GLADSTONE – FITZROY

PIPELINE PROJECT

Environmental Impact Statement

Supplementary Report

**Figure 7 - Powerlink Crossings -
Inset Map 1**

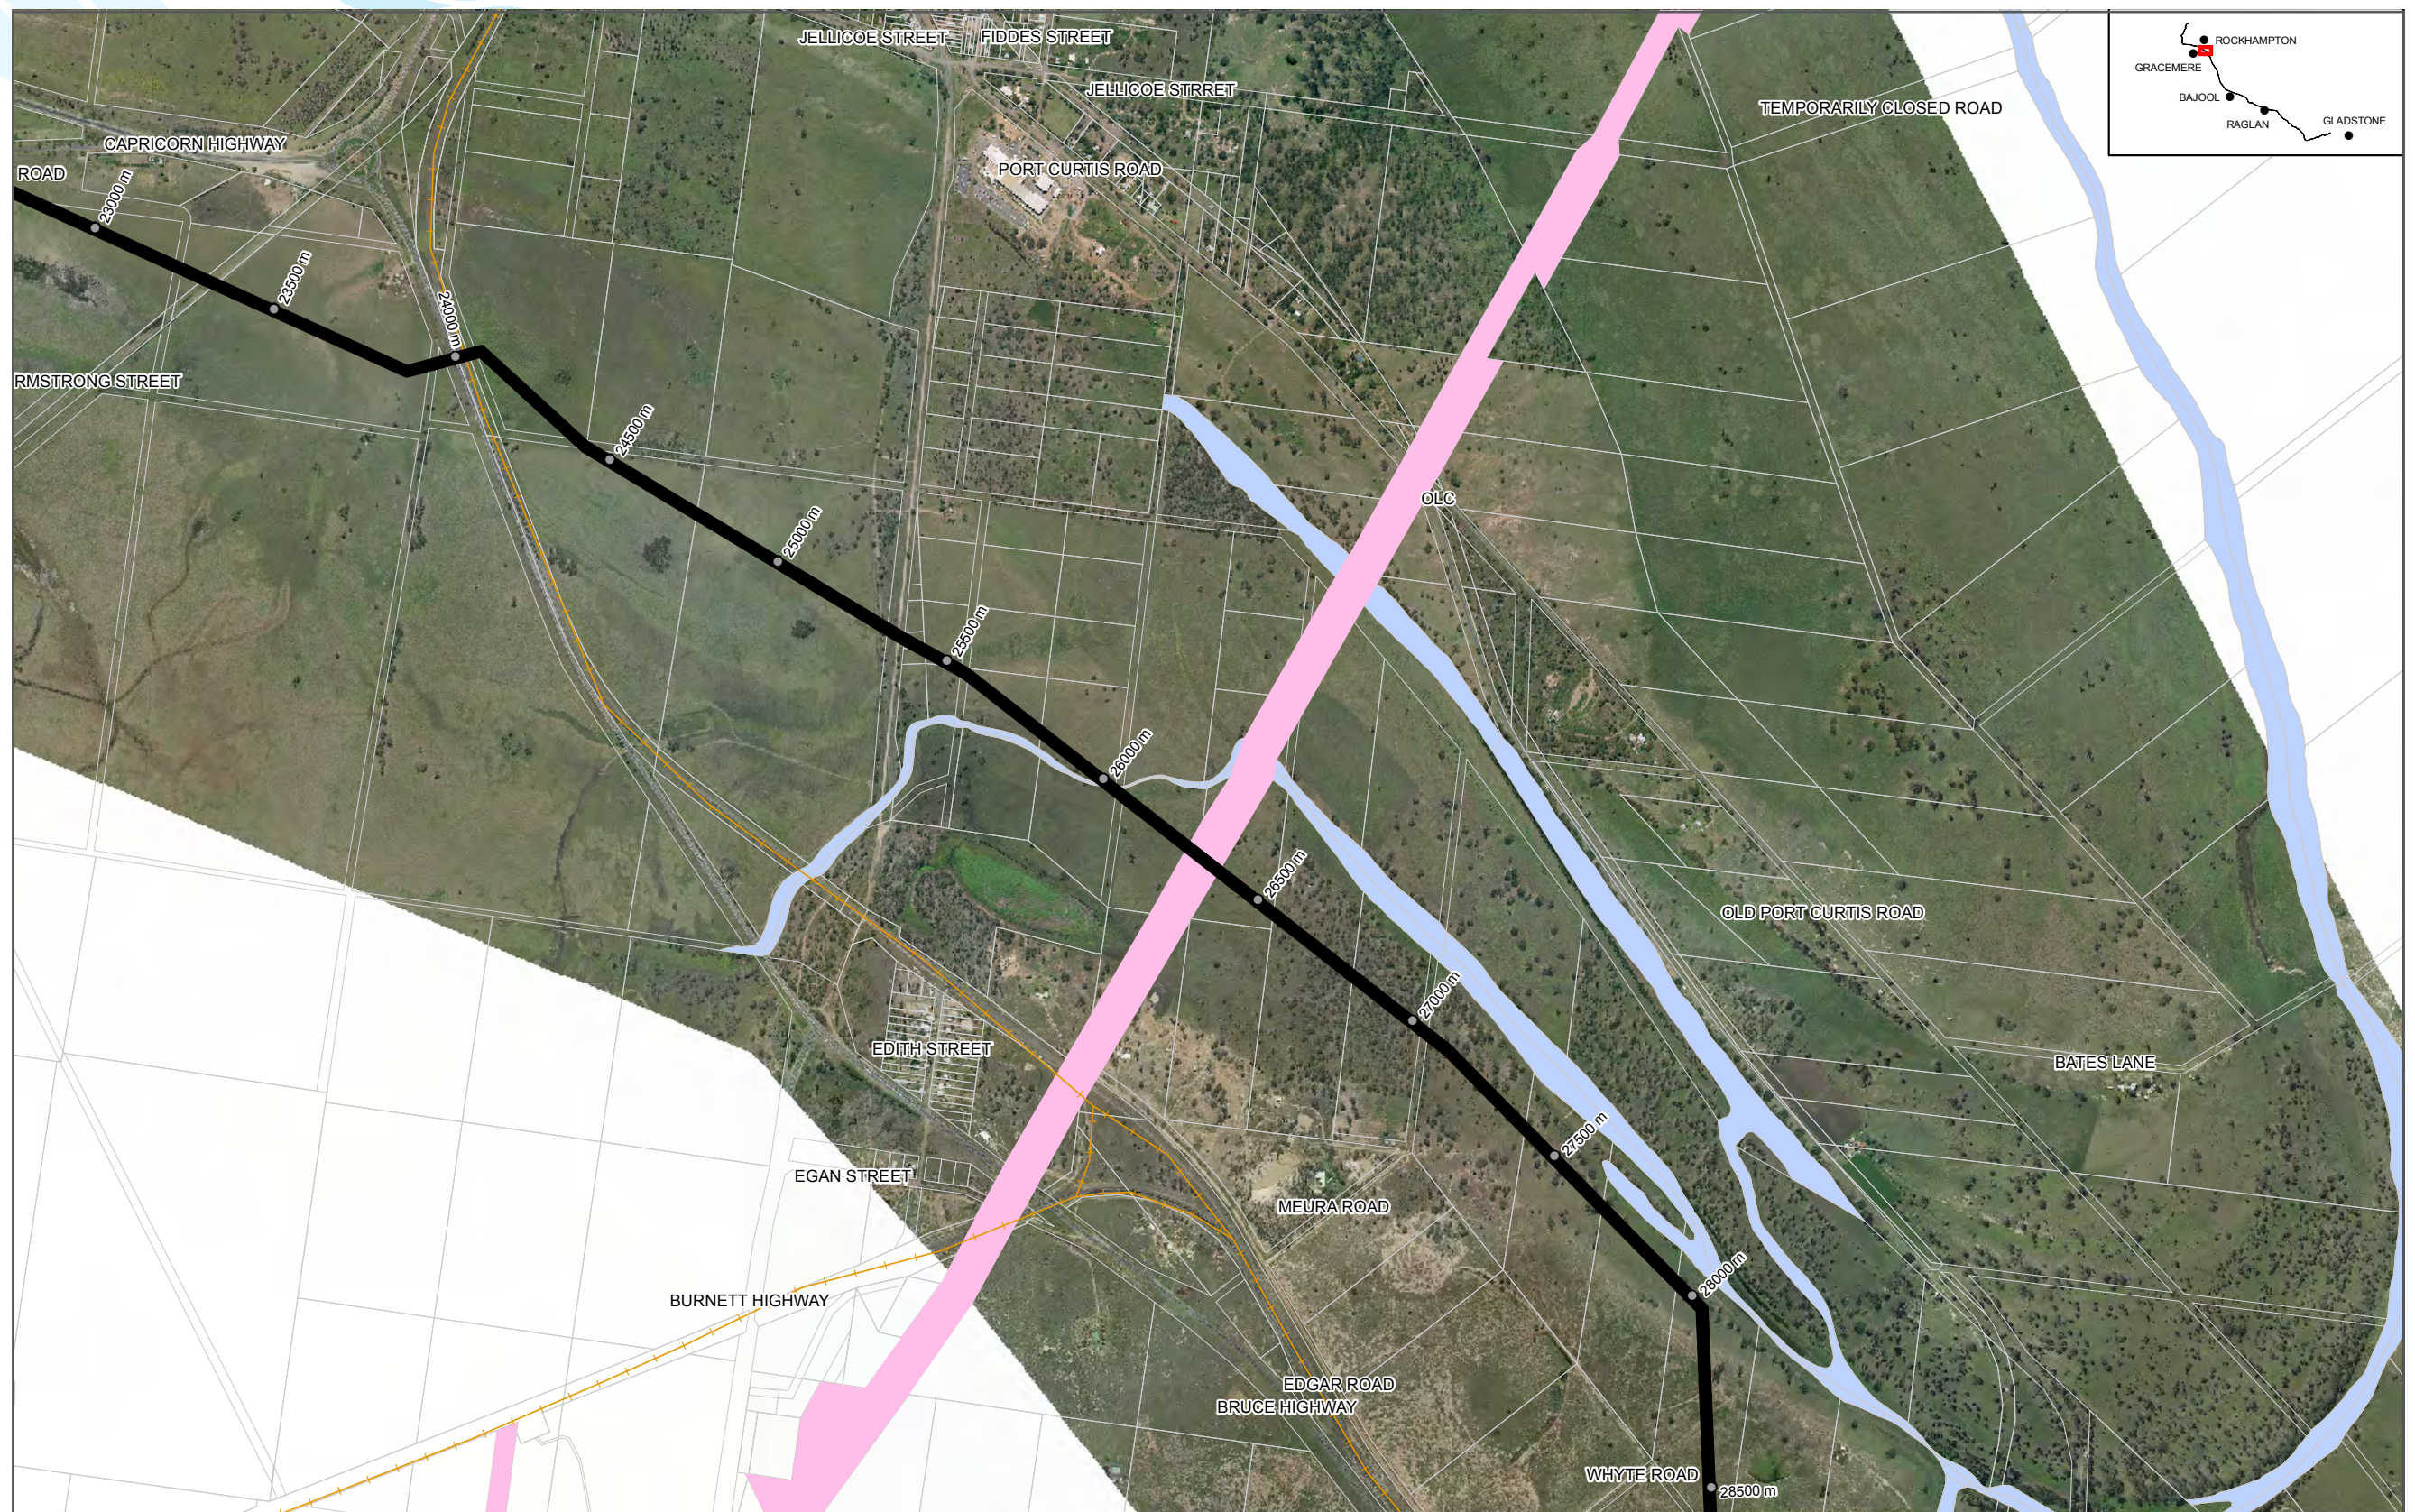
No.	Submitter	Issue No.	Key Issue	Summary of Submission	Response (Section of the Supplementary Report)
Organisations					
16	Powerlink	16.1	Crossings of Power Transmission Lines	With reference to Figure 1.3 of the EIS (Chapter 1, Introduction), Powerlink has identified in its submission several areas where the project will be in close proximity to existing or proposed powerlines.	4.16

16.2	Crossings of Power Transmission Lines	Powerlink requests submission of detailed design plans for the identified crossings once they have become available for review.	4.16

Powerlink has indicated in its submission the places where the pipeline is crossed by electricity transmission lines. Detailed design plans of the crossing points have been requested by Powerlink and will be provided by GAWB as part of the stakeholder consultation process. Powerlink crossings are shown in Figure 7 of this report.

**Figure 8 - Alton Downs
Alignment Options**

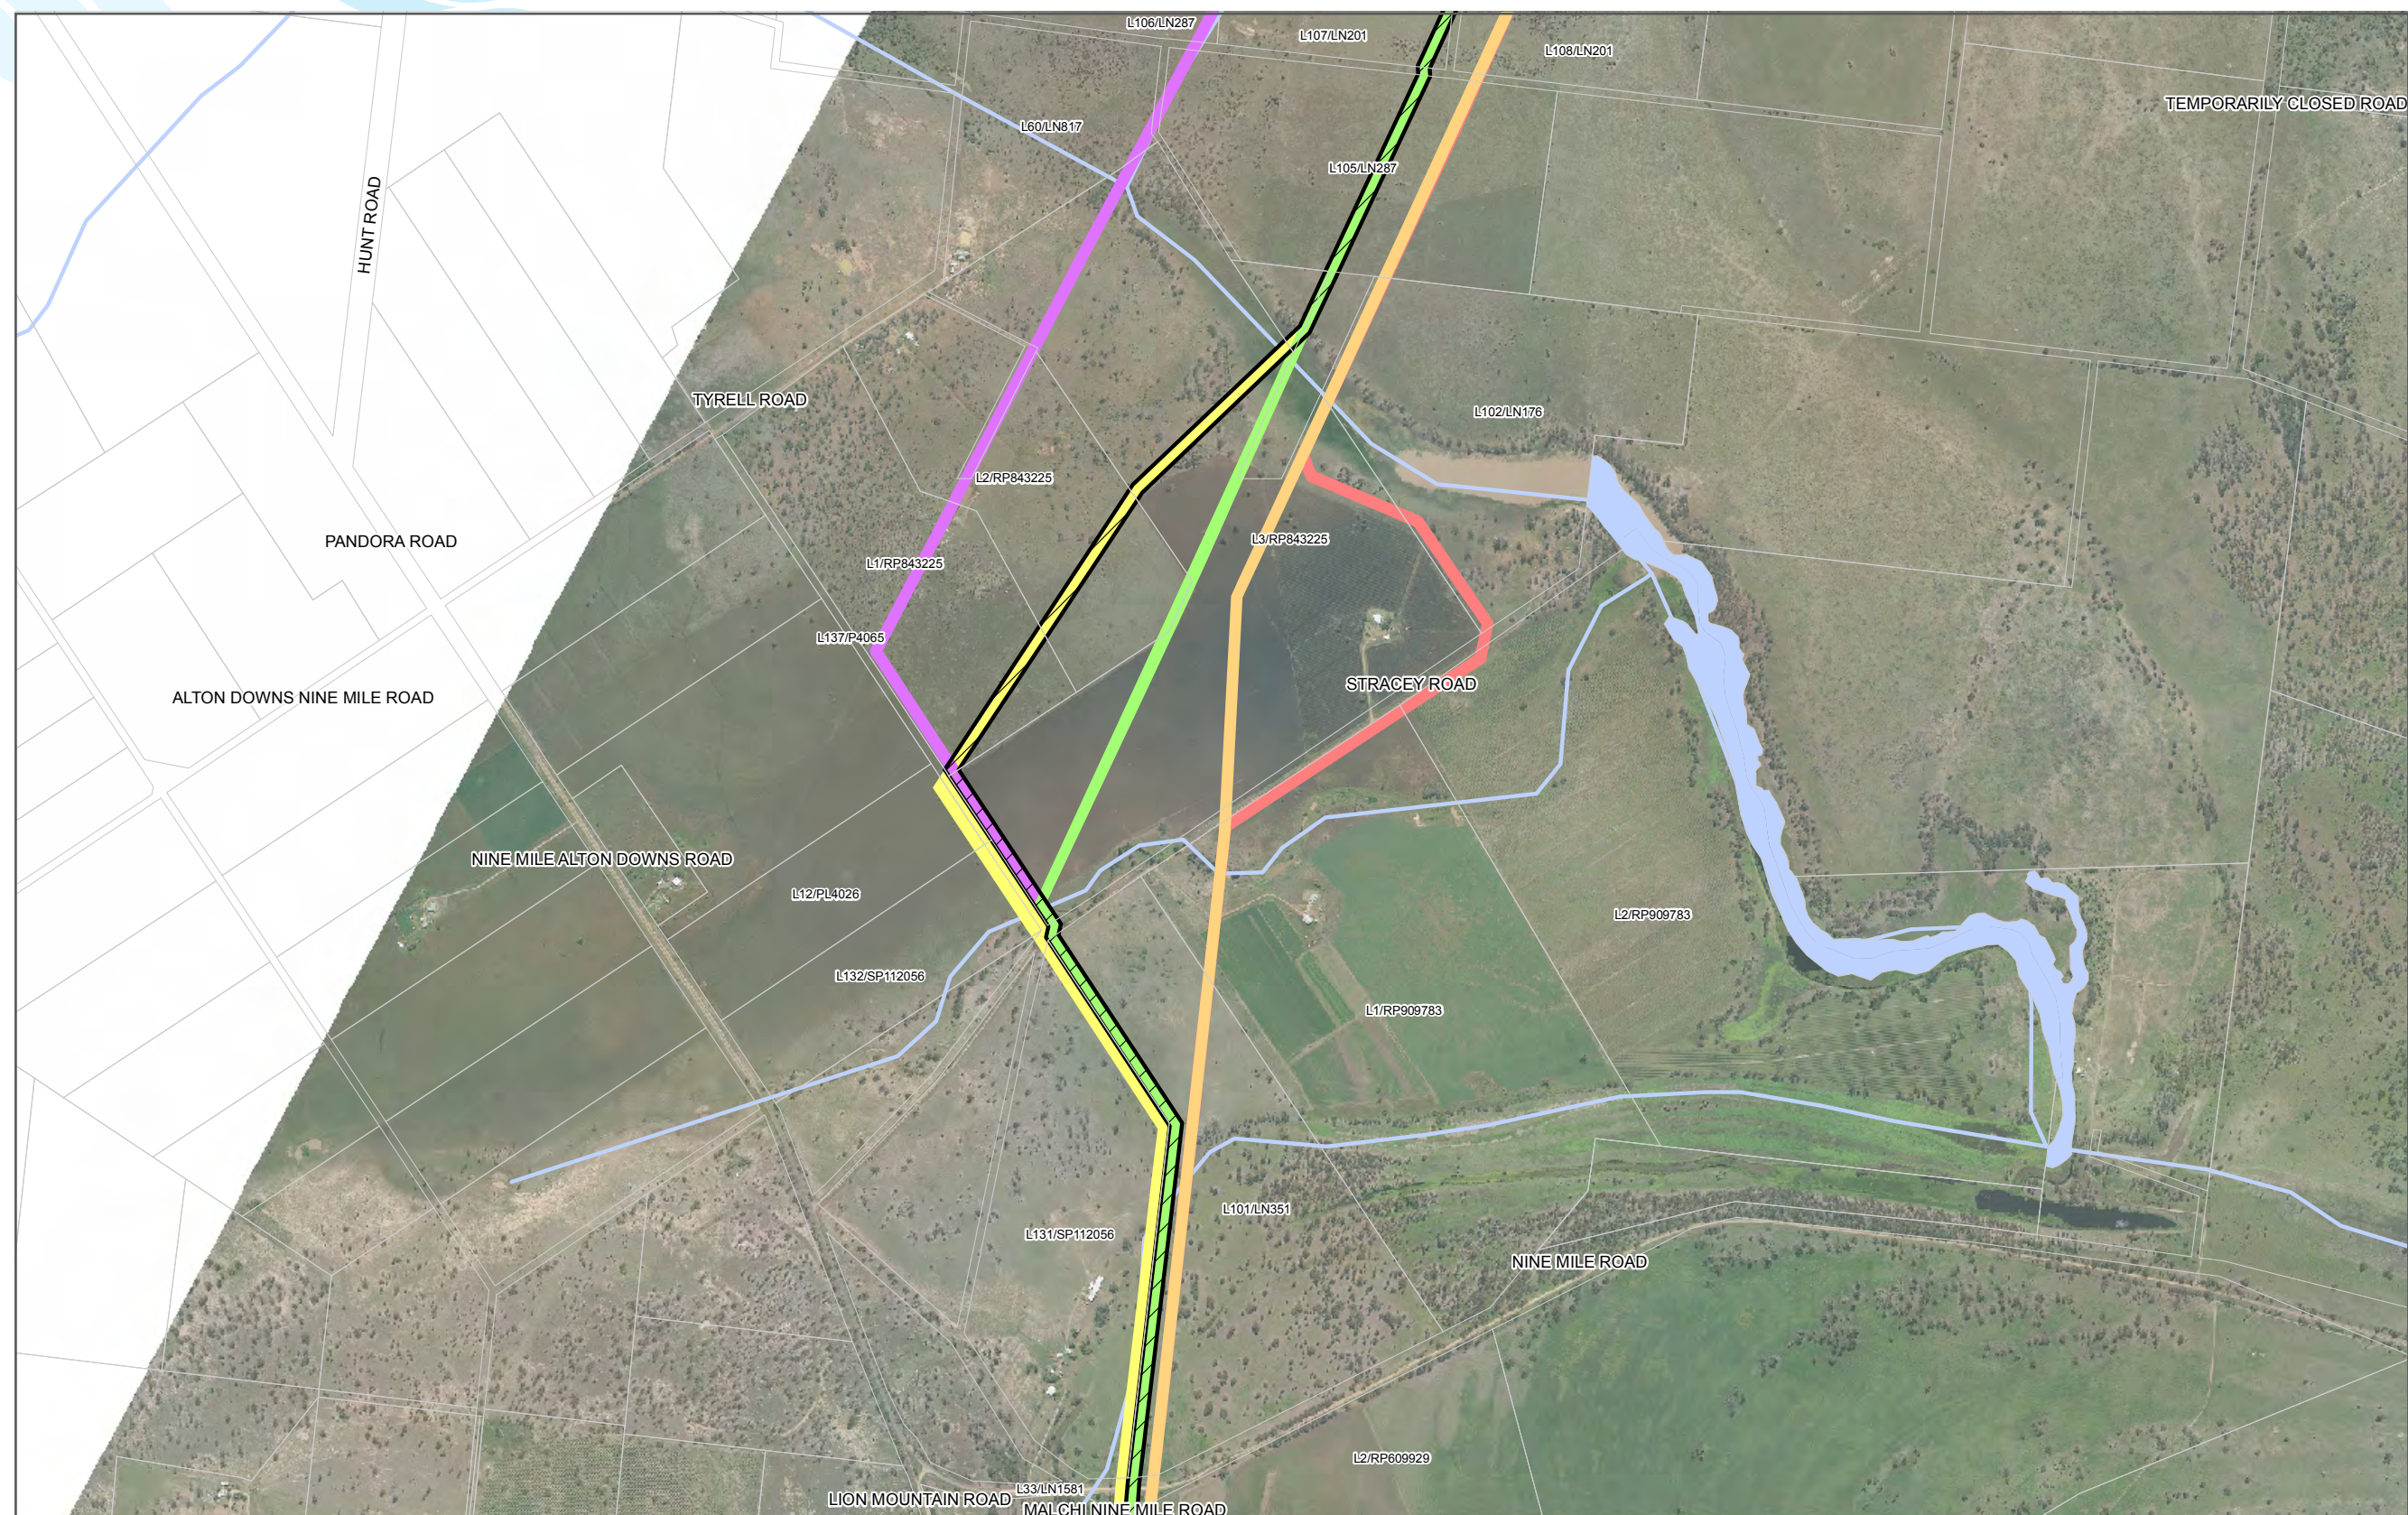
20.2	Pipeline Re-alignment	The submitter questions whether the pipeline alignment has been re-routed due to objections from their neighbours, who have lodged complaints about the pipeline passing through their property due to improvements to their land.	4.20

Private Submitters have raised issues about the proposed route alignment in the Stracey Road/Tyrell Road area at Alton Downs. GAWB has assessed, at different stages of the project, six different route options in this area, the options varying in length from 14.41 to 15.21 km. Details of the route options are shown in Figure 8 of this report and are summarised below in Table 18.
